RE: 3500 Pickett Road  
Code Compliance Review

# CODE COMPLIANCE REVIEW FOR THE PROPOSED RESIDENTIAL DEVELOPMENT AT 3500 PICKETT ROAD

1. Case Number:	BAR-20-00113
2. Address:	3500 Pickett Road
3. Tax Map Parcels	58 1 02 021
4. Request:	50 townhouses and site improvements
5. Applicant:	EYA Development LLC
6. Applicant's Representative:	Aakash Thakkar
7. Status of Representative:	Agent
8. Current Zoning:	RL Residential Low
9. Proposed Zoning:	PD-R Planned Development Residential

**Figure 1 – Aerial view of Project site**

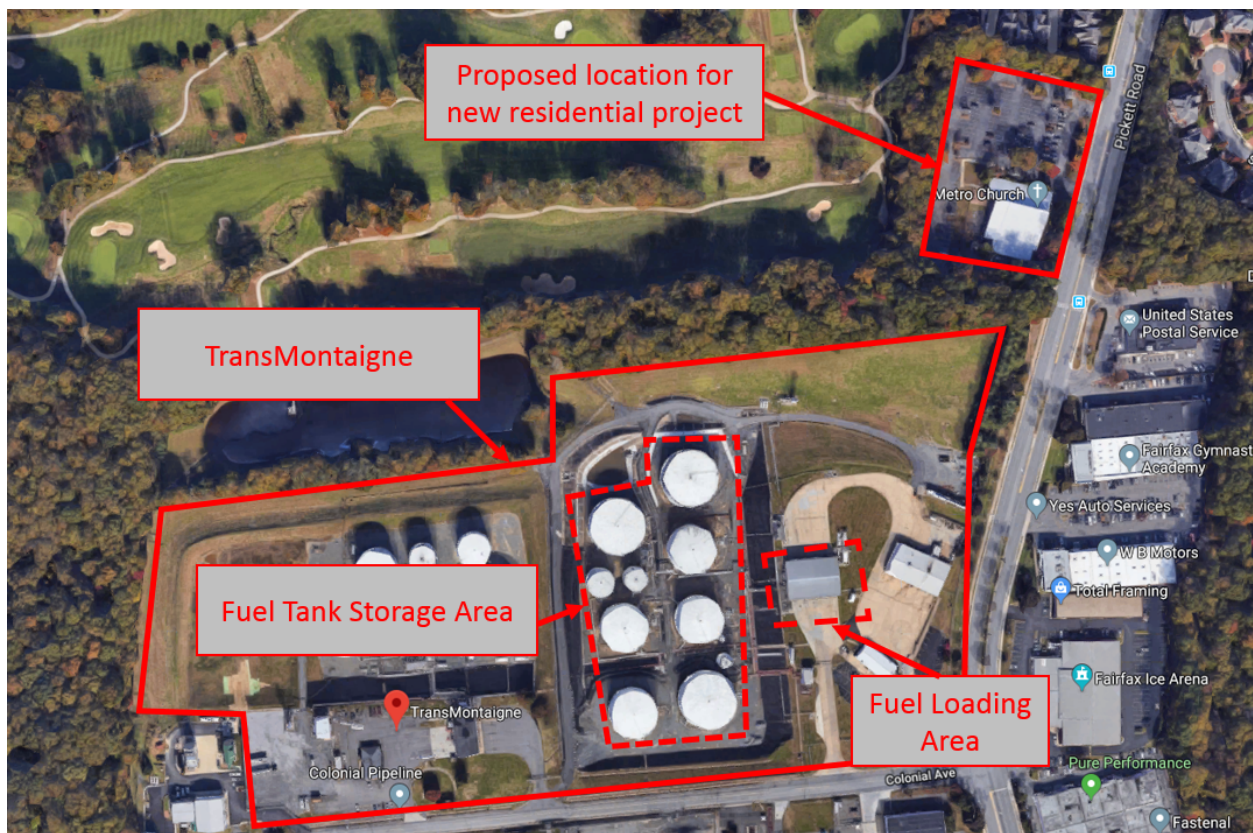
The TransMontaigne tank farm facility is located at 3790 Pickett Rd., in Fairfax VA. Figure 1 below shows the location of the tank farm relative to the proposed residential housing project.
